re: **Review of Jan 2023 Documents Submitted to USACE by the Summers End Group LLC**  
**USACE Permit Application #SAJ-2004-12518**

# Review of Applicant “Summers End Group” Jan 2023 Submission to USACE

US Army Corps of Engineers Permit Application Number SAJ-2004-12518

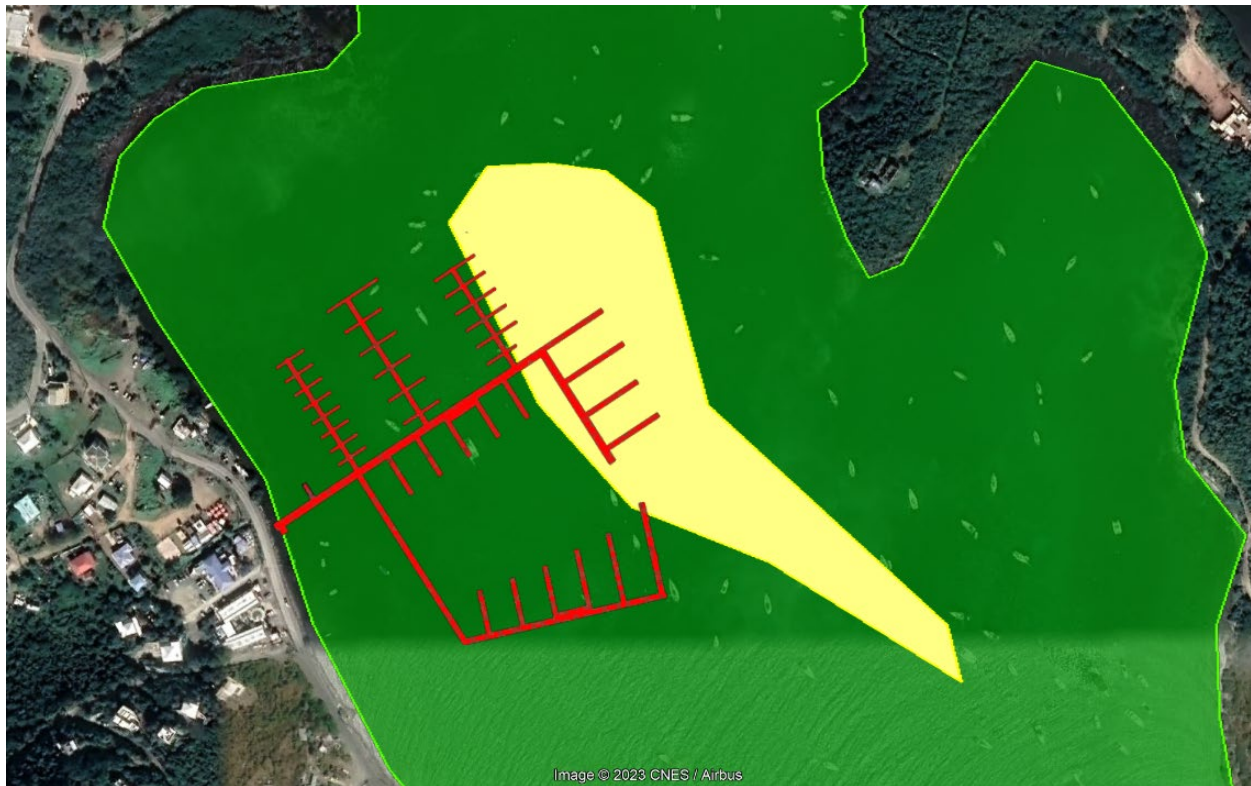
In the current (2023) submission the method for calculating shading impacts due to boats was changed from the 2017 submission, resulting in a reduction of 78% in the boat shading impact. The 2023 document states:

"At the maximum capacity and at the maximum sized boat in each slip there will be 1.219 acres (53,080sq.ft) of shading due to vessels within the area of dense seagrass colonization. It can be assumed that 50% of the seagrass (26,540 sq.ft. [equal to 0.61 acre]) in this footprint will be lost due to vessels being docked more than 2 weeks at a time."

The lack of scientific rationale in Applicant's shading impact statements should be readily apparent from an examination of these two statements. The estimate in 2017 was based on 5.65 acres of boats producing 50% seagrass loss, or 2.825 acres. The estimate in 2023, with an 18% reduction in total boat area and a minor (<5%) reduction in seagrass cover, is only 0.61 acres of impact. This is equivalent to a 78% reduction in estimated boat impact, resulting from an 18% reduction in boat area, an illogical and incorrect result.

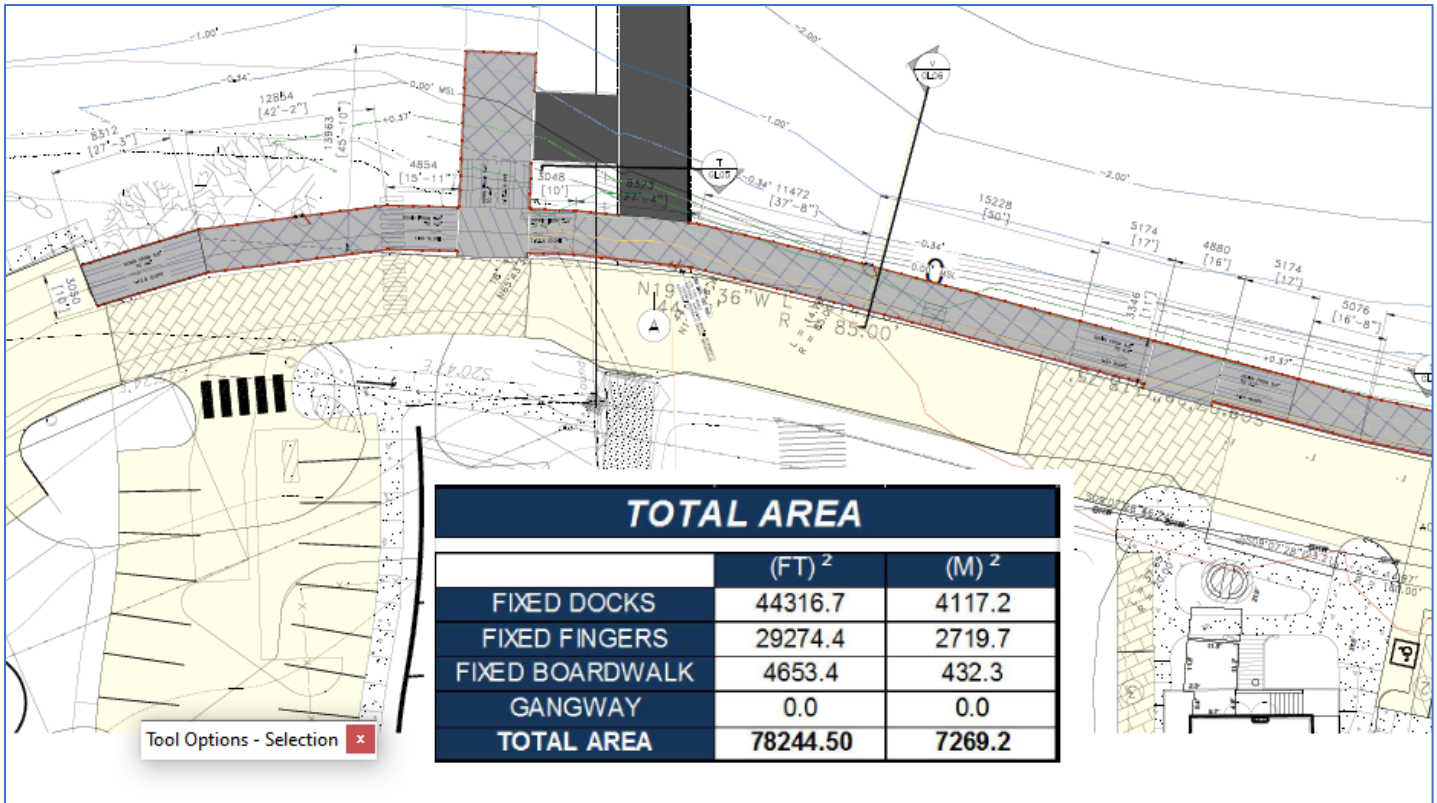
There are multiple incorrect minimization claims made by Applicant in “Exhibit 16 – Minimization Images” including the following:

- **Exhibit 16 – Minimization Images, Figure 1:** Applicant’s claim that the “Initial Total Dock Area” was 91,573.76 sq ft is simply incorrect. This initial total dock area was approximately 75,115 sq ft. The larger figure is, presumably, either an error or a plan which was never submitted for permitting.
- **Exhibit 16 – Minimization Images, Figure 3:** Applicant’s claim that the initial design included a 60’x80’ structure over the water is likewise incorrect – such a structure never appeared in any public notice for the project. It may have been a conceptual plan by Applicant, but it has never appeared in a permit application or public notice.
- **Exhibit 16 – Minimization Images, Figure 7:** Applicant’s claim that the initial design included 24 mooring balls is likewise incorrect; the initial public notice included 12 mooring balls to the south of the marina.

**THE 2023 PLAN MODIFICATIONS**

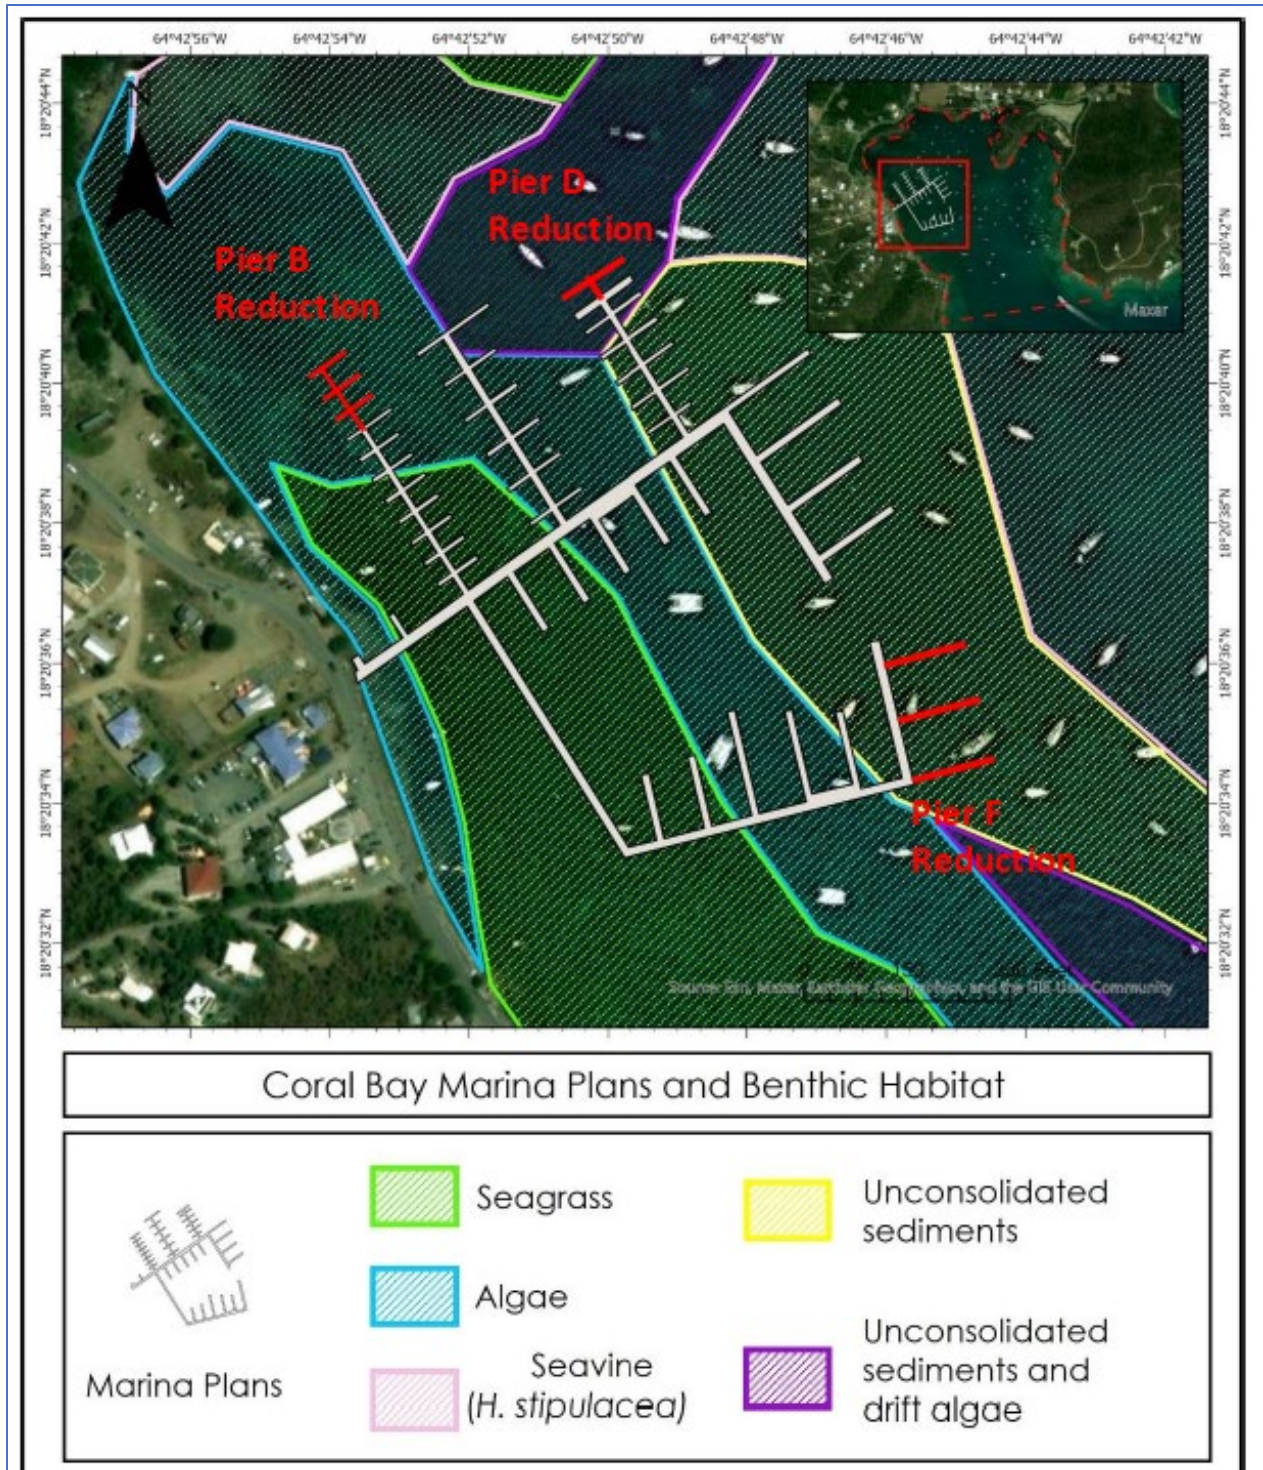
The latest dock modification has removed 5,758 sq ft of finger piers, primarily in the north marina area as compared with the 2017 plans. If the “Fixed Boardwalk” is not included in the area comparison, the 2023 plan is a total of 67,833 sq ft, which is 9.7% less than the initial plans in 2015 (75,115 sq ft). If the boardwalk is included in the area comparison, the 2023 plan is 3.5% less than the initial plans.

These small reductions in scale (3.5% or 9.7% depending on whether the boardwalk is included or not) do not, however, tell the whole story about habitat impacts. A reduction in structure size is only effective minimization if it results in lesser impacts to protected resources. In the case of this project a significant portion of the eliminated structures are located over deep water habitat which is largely devoid of SAV, and so this reduction in scale is of little or no consequence in reducing direct habitat impacts, which is the purpose of avoidance and minimization.

## **MINIMIZATION WITH SUBSTANTIAL REDUCTION IN IMPACT IS PRACTICABLE**

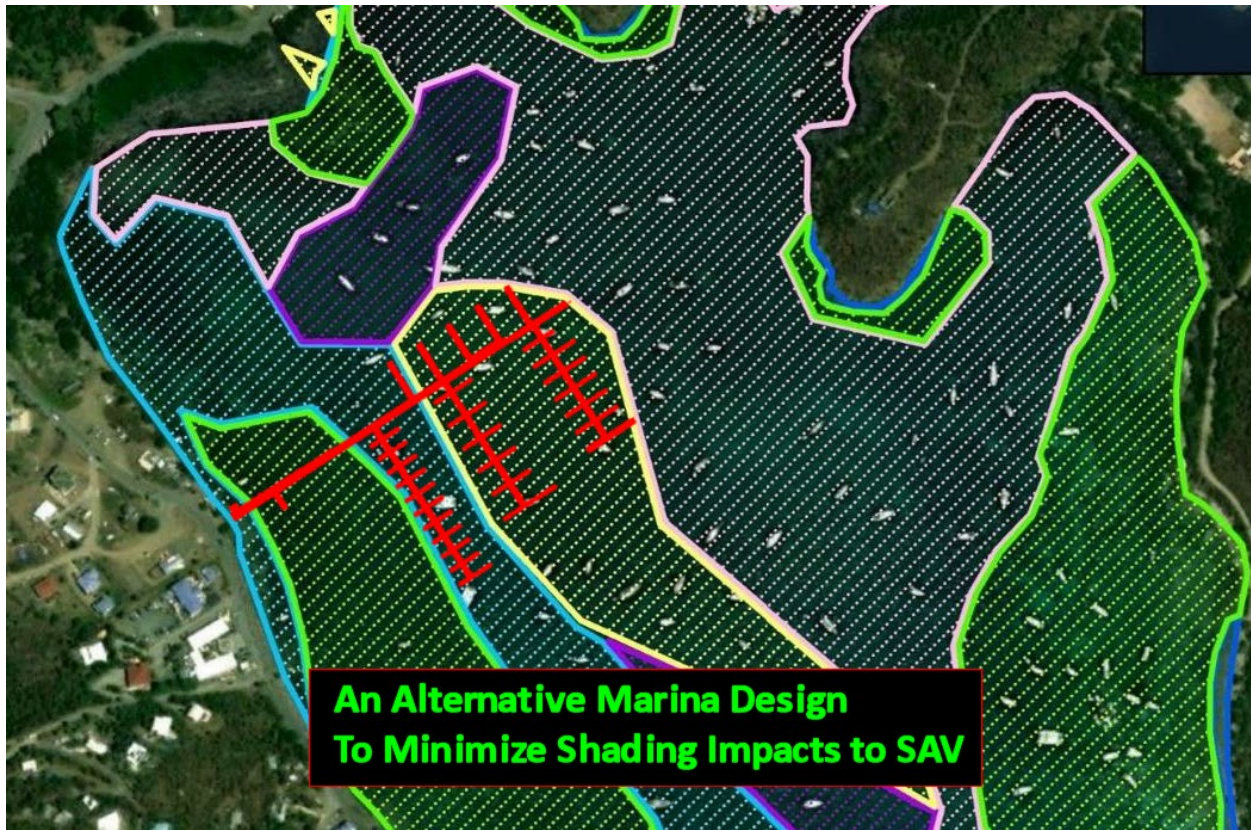
In order to minimize impacts to SAV to the maximum extent practicable the majority of the marina slips should be located over the deeper, unvegetated portion of the harbor. The deeper water will significantly reduce the resuspension of sediments from vessel maneuvers and the unvegetated benthos will not be impacted by shading.

One possible design modification is illustrated below. This design is essentially Applicant's 2023 marina design, “flipped” 180 degrees and relocated slightly to the north.

Figure 3: ThruFlow Grated Decking

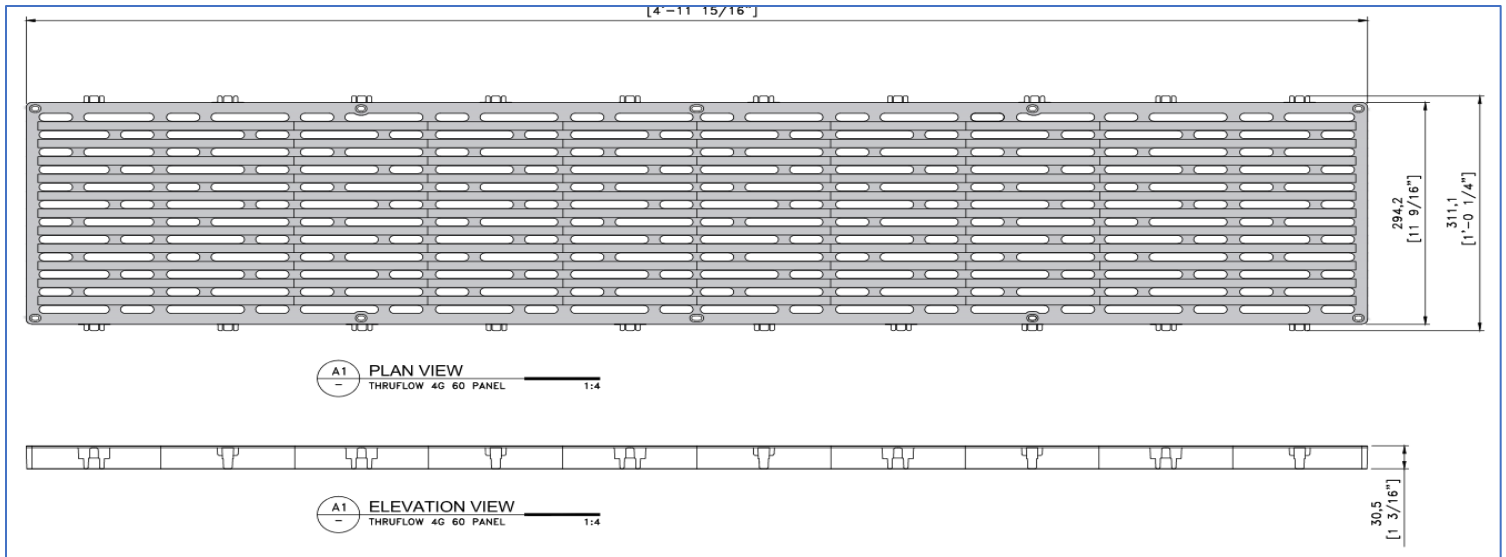
In addition to the shading modeled in this section, we also have looked at the physical geometry of the “ThruFlow” grated decking proposed by the applicant for use in the Coral Bay marina structures. This grated decking has longitudinal openings approximately ½” wide by 3-7” long throughout the deck section. The section is 1.25” thick, as shown in the engineering drawing below:

Because the side walls of the deck openings are substantially deeper than the opening itself (1.25" deep by 0.5" wide), the sides of the opening will obscure the opening anytime the sun's altitude is less than  $68^\circ$  ( $\arctan(1.25/0.5)$ ). The actual degree of shadowing of the cell opening by the cell wall depends on the angle of the deck section as well as the elevation of the sun. But under most circumstances the "ThruFlow" grated decking will allow far less than the best-case 43% of light penetration claimed by the applicant. In fact, the only time this physical geometry will allow 43% light penetration is with the light source directly overhead, which, at the latitude of St John, happens for only 2 days per year. A photograph of ThruFlow grated decking illustrating the shading effect of the side walls is shown below.

Figure 6: Proposed Navigation Channel

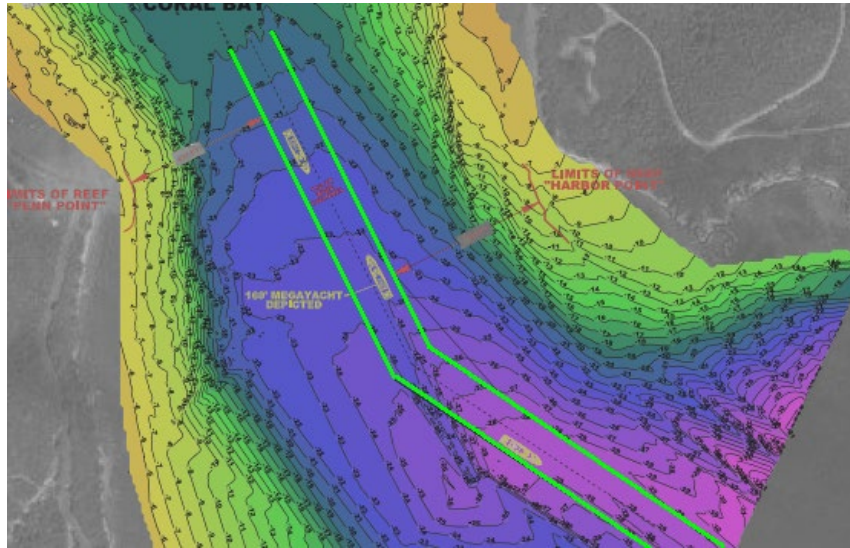
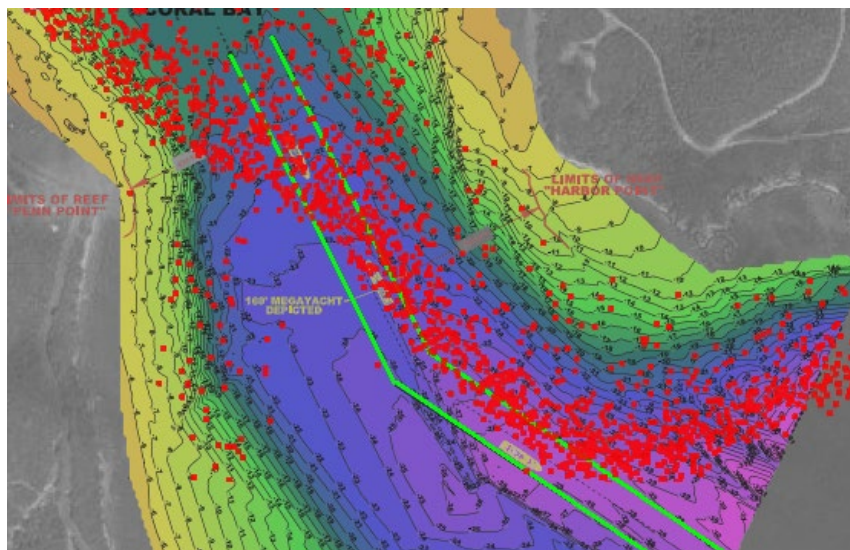
The first illustration below is the navigation channel proposed by the applicant (highlights added to outline the channel):

The next illustration overlays the PTM particle map on the channel map, demonstrating the overlap between vessel navigation and particle transport locations.

Without further validation of the PTM model we cannot say with any certainty if this is a significant risk, however all of the models prepared by applicant as well as prepared by us indicate that there is a southeasterly current in the middle of the harbor mouth, and this is where the channel is proposed to be located. With a draft of 1m or greater there is a significant risk of resuspending sediments that have settled to 1-2m as larger yachts traverse the channel.
